TOWN OF BLUFFTON

STAFF REPORT

MEETING DATE:	January 27, 2016
PROJECT:	Nissan & Infiniti Dealerships – Certificate of Appropriateness – Highway Corridor Overlay
PROJECT MANAGER:	Erin Schumacher, AICP, Senior Planner

1. **COFA-12-15-9448.** A Certificate of Appropriateness to allow the development of two car dealerships consisting of two buildings ranging in size from 18,000 SF to 25,000 SF and associated site improvements on approximately 11 acres of property fronting US Highway Route 278, zoned Buckwalter PUD within the Buckwalter Business Park Master Plan.

ELEVATIONS

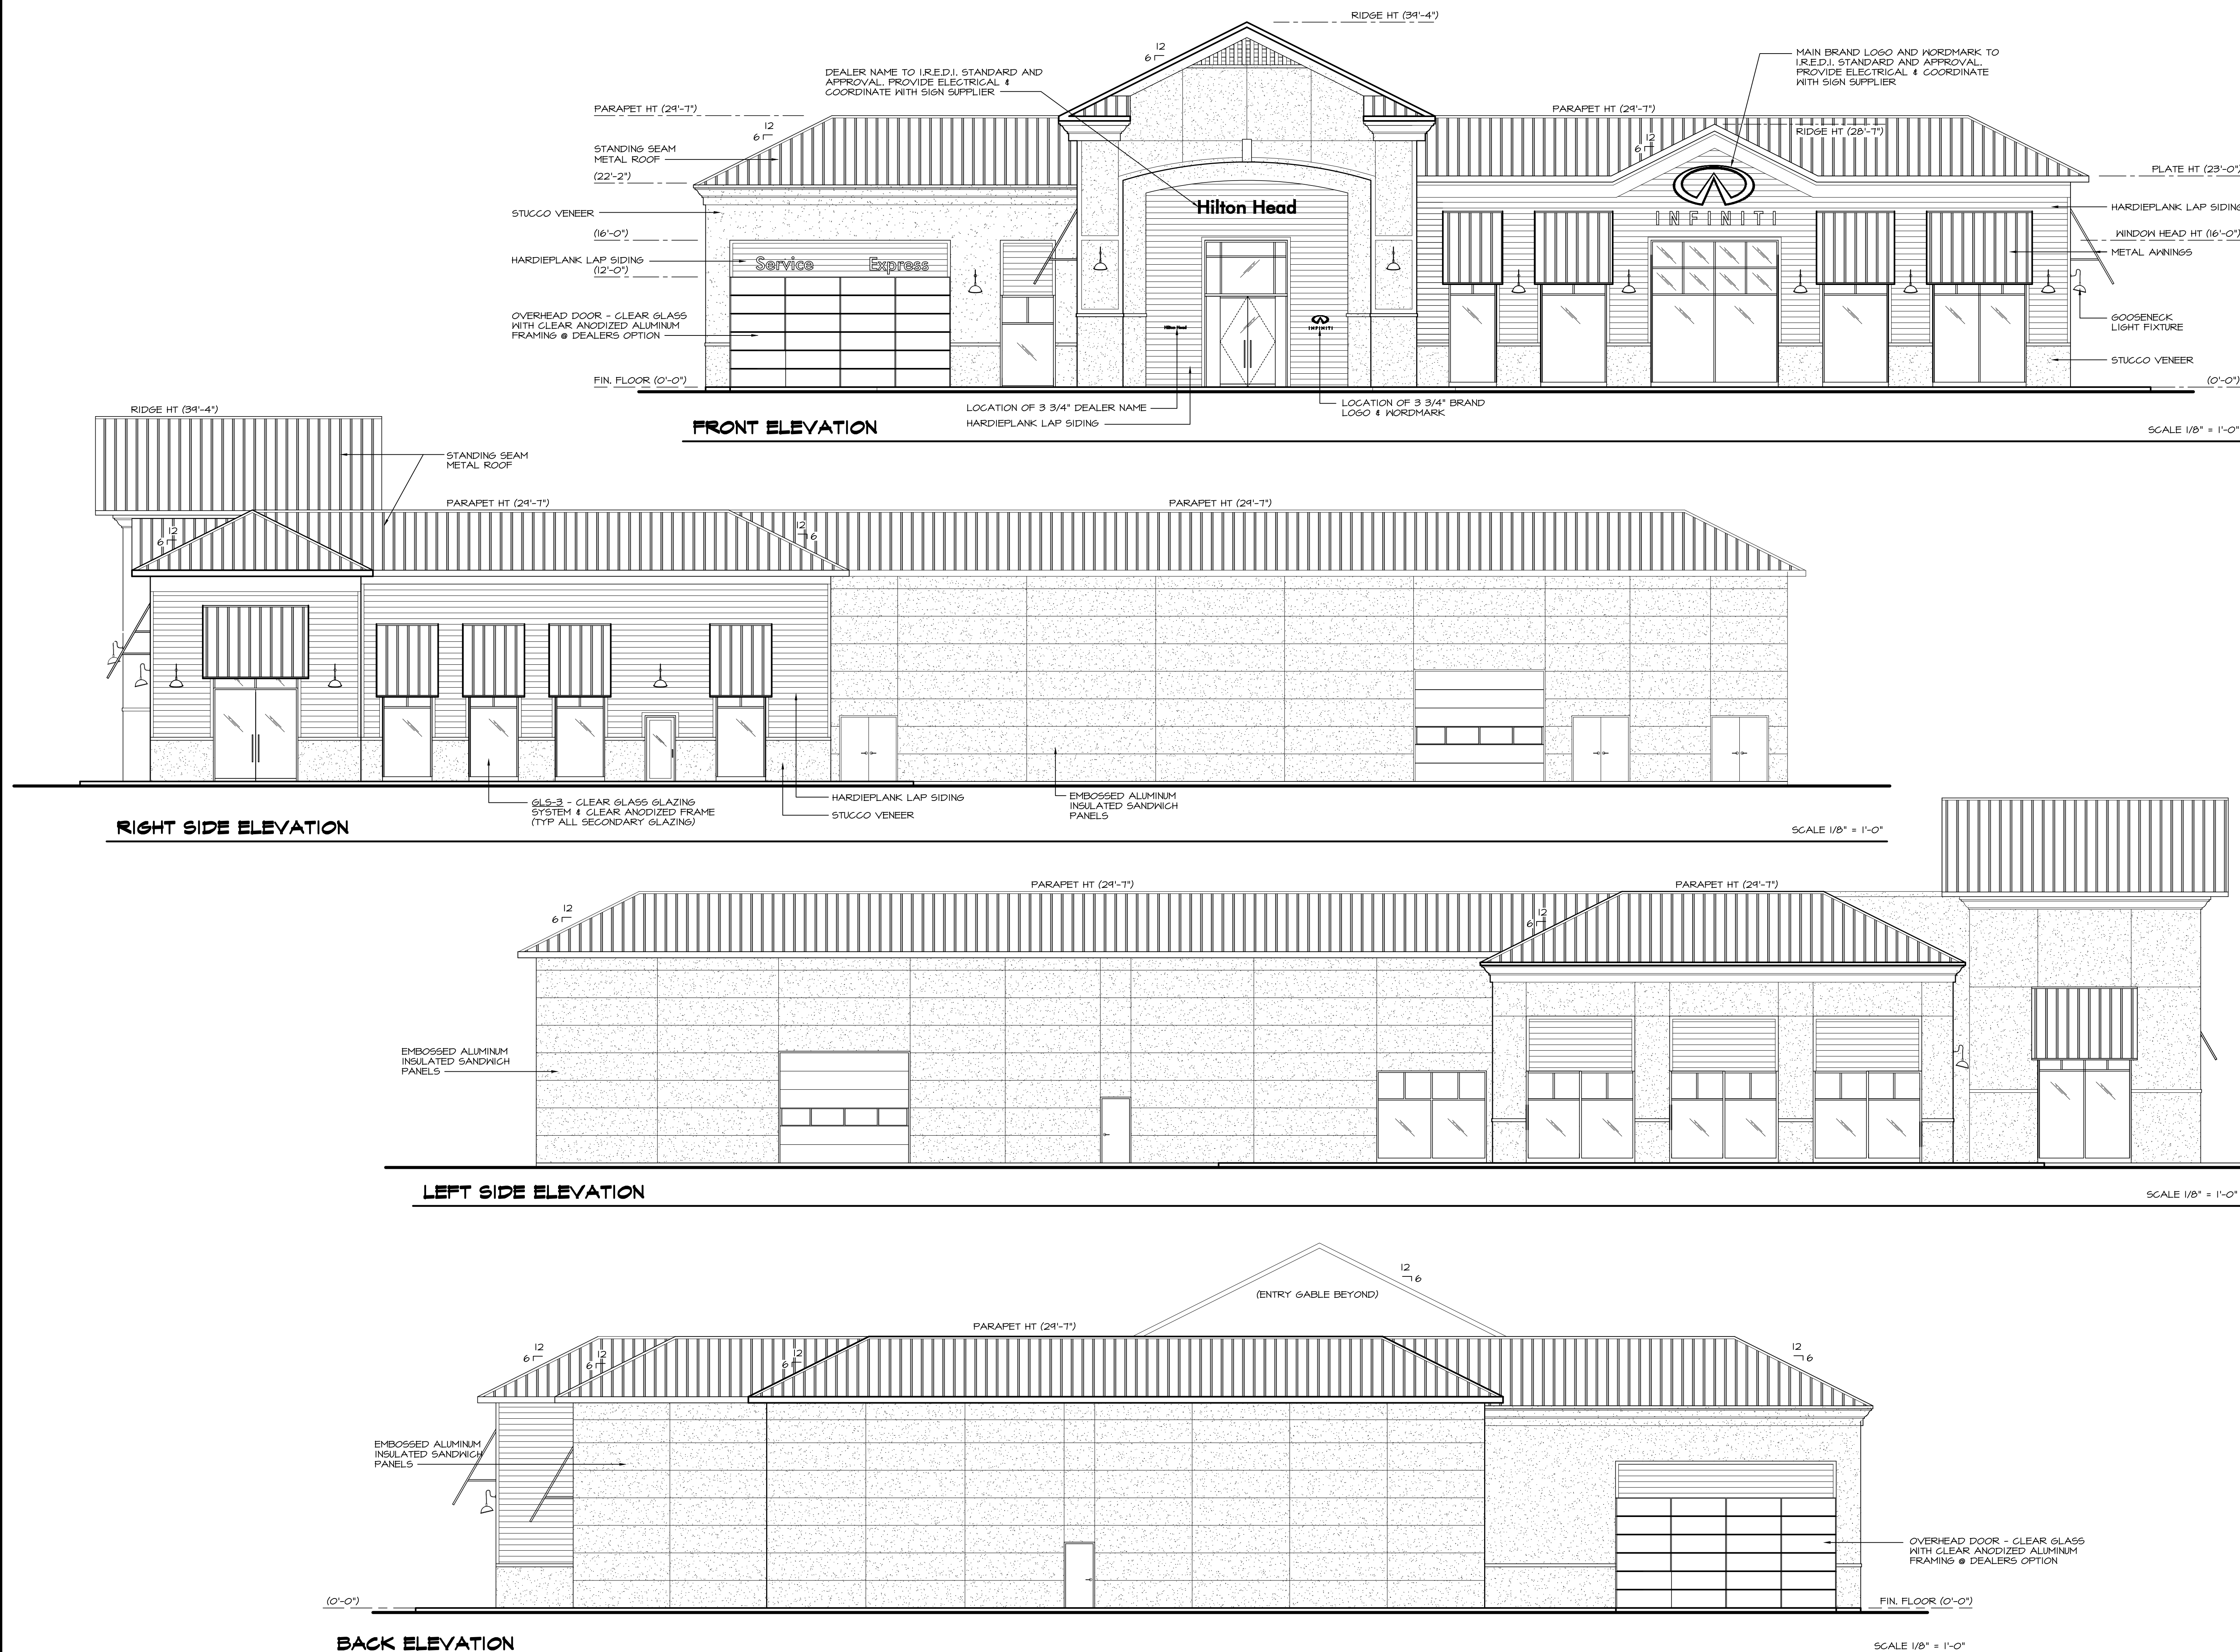
As proposed, the design for the Infiniti Dealership utilizes embossed aluminum sandwich panels at the side and rear of the building. This materials does not resemble painted wood clapboard as required and must be revised to a more appropriate material.

- c. Per Section 4.23.3.A.3.a. of the Beaufort County ZDSO, the proposed embossed aluminum sandwich panels at the side and rear of the building at the Infiniti site must be revised to a more appropriate material.

ELEVATIONS

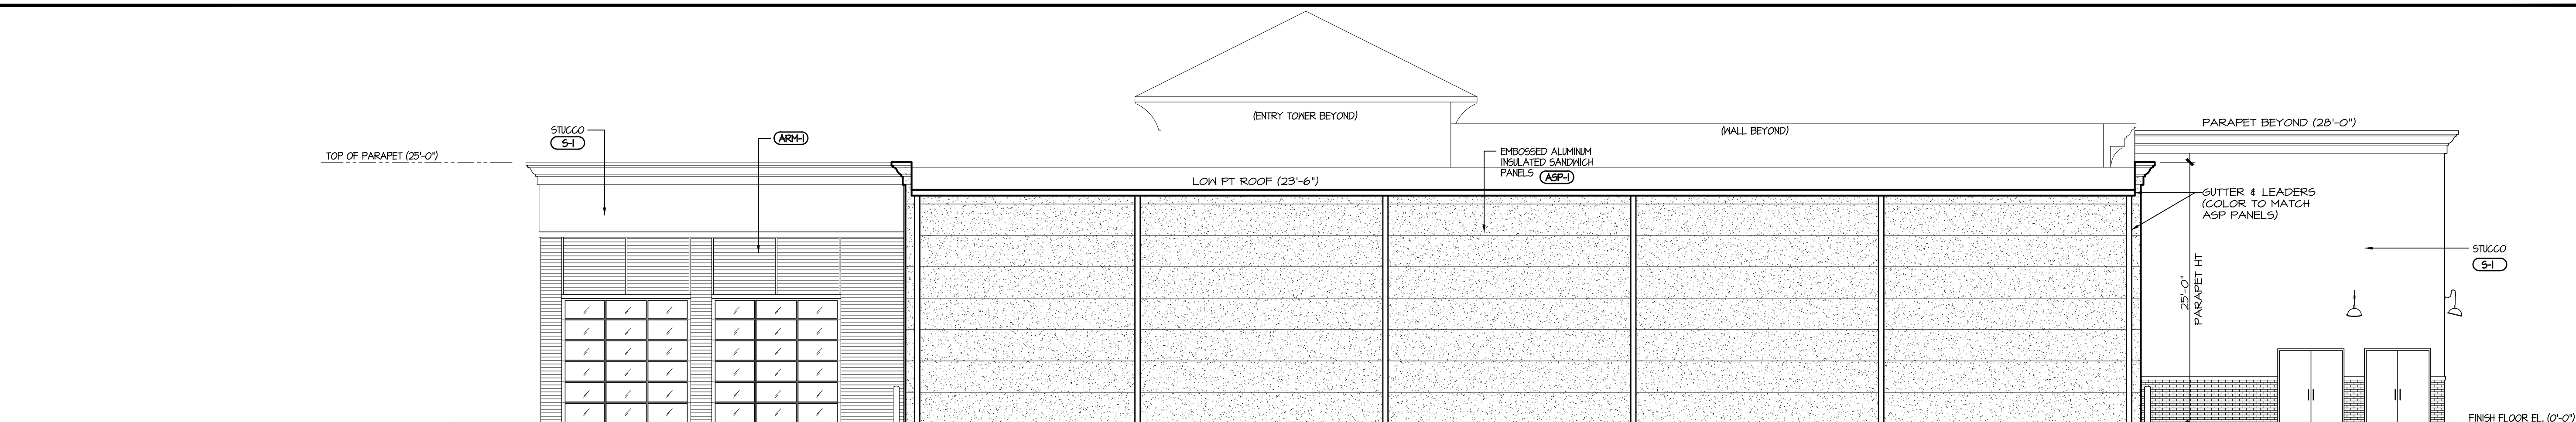
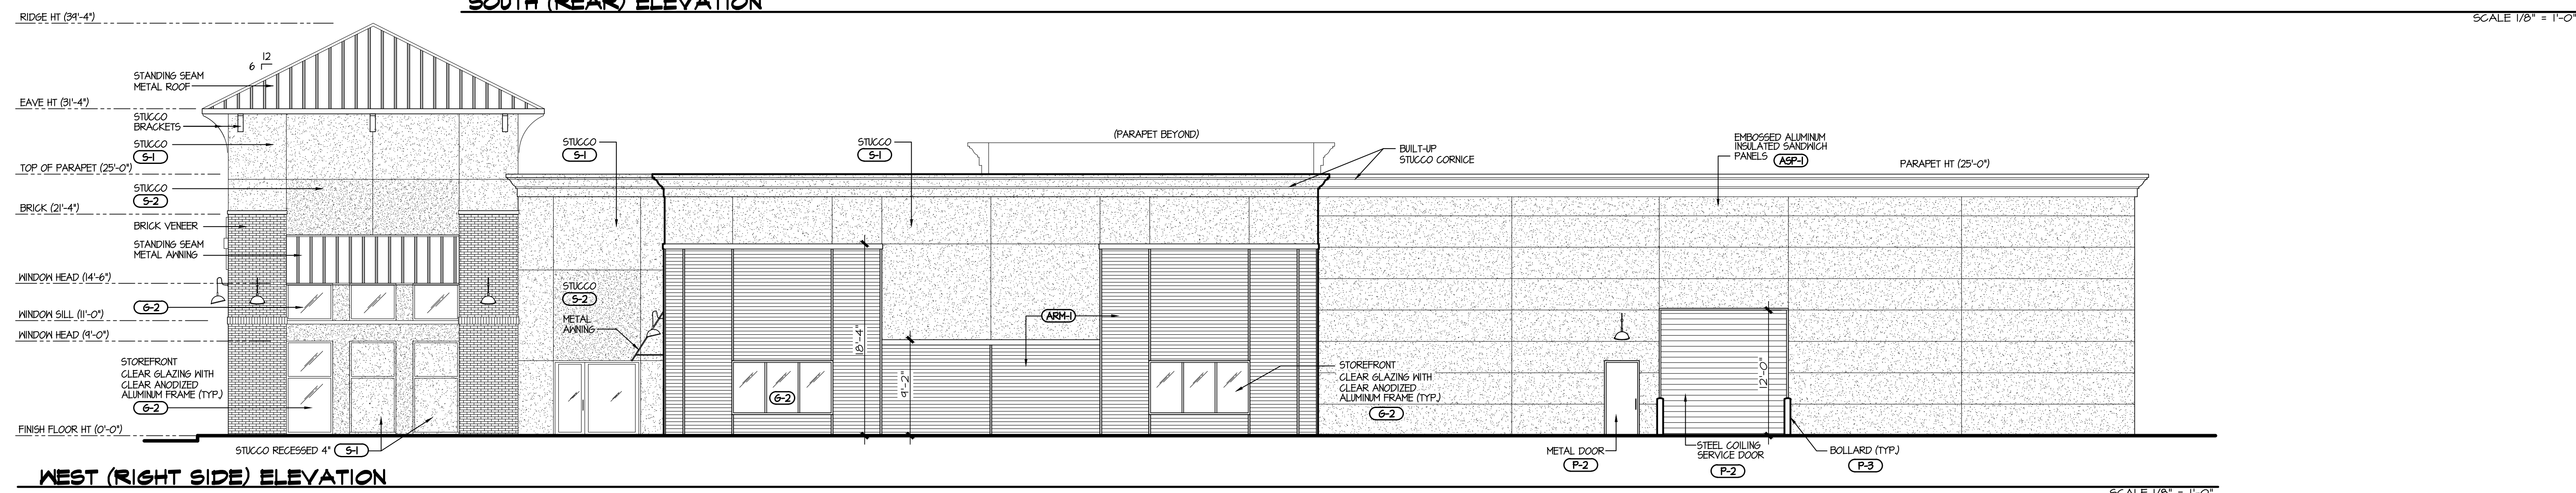
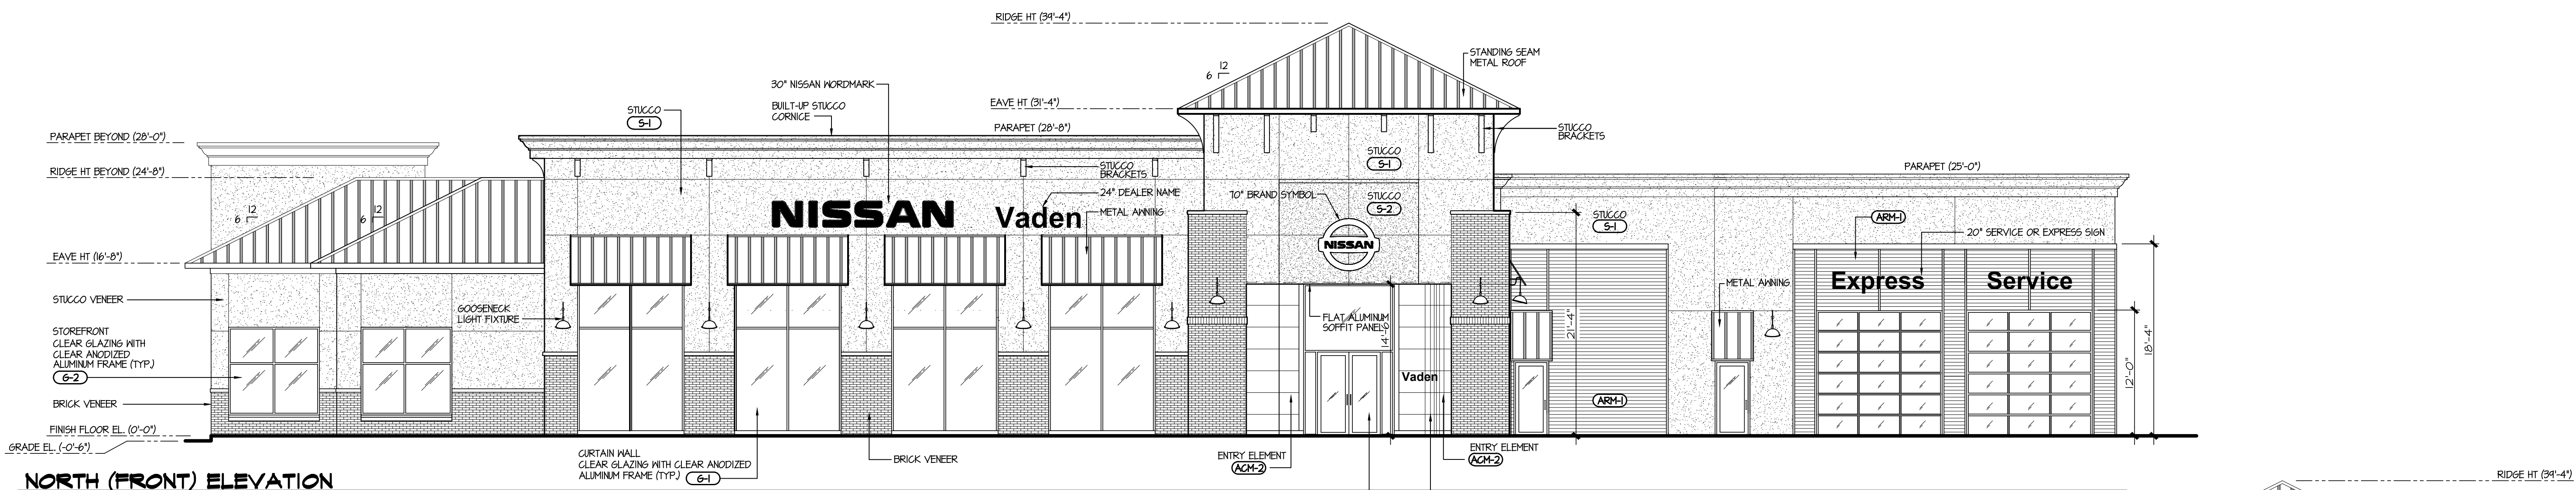
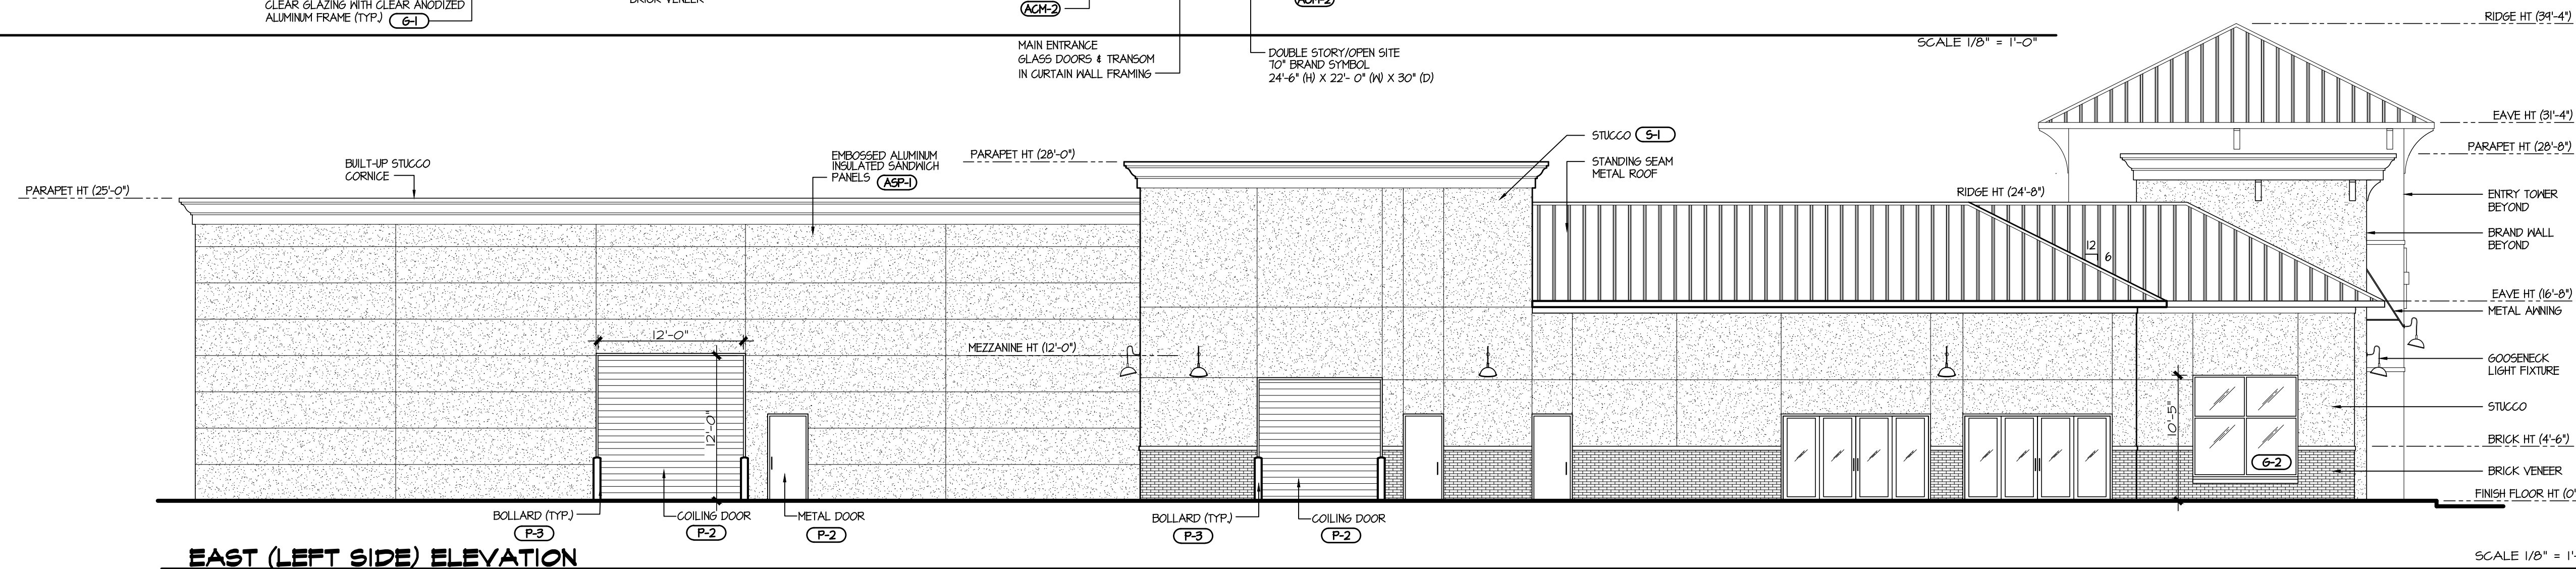
As proposed, the design for the Nissan Dealership utilizes embossed aluminum sandwich panels at the side and rear of the building (ASP-1) and a corrugated steel siding (ARM-1) around the service entrances.

These materials do not resemble painted wood clapboard as required and must be revised to a more appropriate material.

- b. Per Section 4.23.3.A.3.a. of the Beaufort County ZDSO, the proposed embossed aluminum sandwich panels at the side and rear of the building (ASP-1) and a corrugated steel siding (ARM-1) around the service entrances at the Nissan site must be revised to a more appropriate material.
